File: cphp82001-pcb.kicad_sch

Title: CALCPACK HP 82001

Size: A4	Date: 2024-04-17	**Rev: 3.5**
KiCad E.D.A. kicad 7.0.10		Id: 1/1

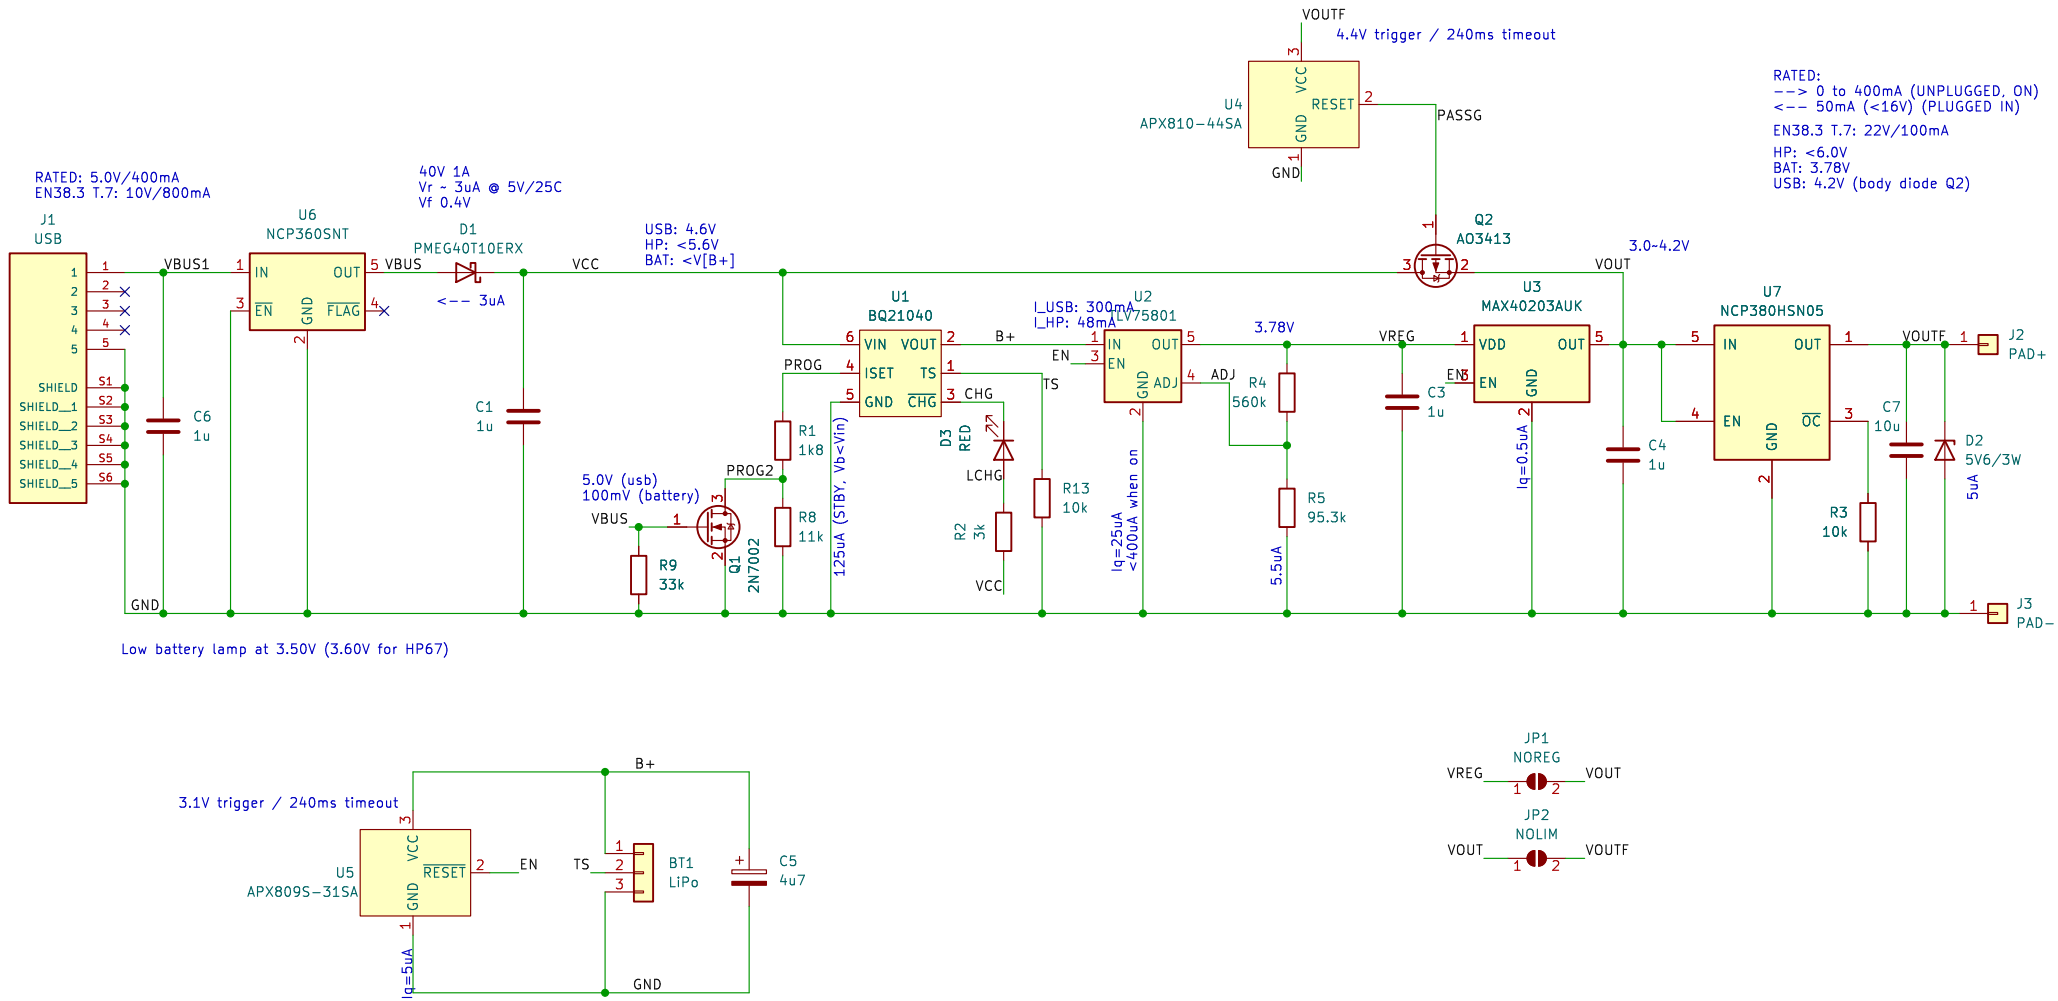
REV1 ADD Q1,R8,R9

REV1.1 U2=TPS73101, U4=S-8261ABJMD, R4=300k, R5=160k, update notes

REV1.2 change D1 to 1N5817, change D2 to 5V6, R8=24k, Add C6

REV2 BOARD LAYOUT CHANGE

REV3 ADD U6, C6, F1. change U4 to TPS3808 (+C4,R6,R7,R10,R11), change U1 to BQ21040, add Q2,D7,R13, move C2, add C7, new name

REV 3.1 remove F1, change R5 to 95.3k

REV 3.2 change U5 to APX

REV 3.3 Add U4,Q2 for active backfeed

REV 3.4 Change R1 to 1k8, R8 to 11k, C7 to 10u

REV 3.5 Add U7, C4, JP1, JP2, move U4 pin3 to VOUTF, del C2
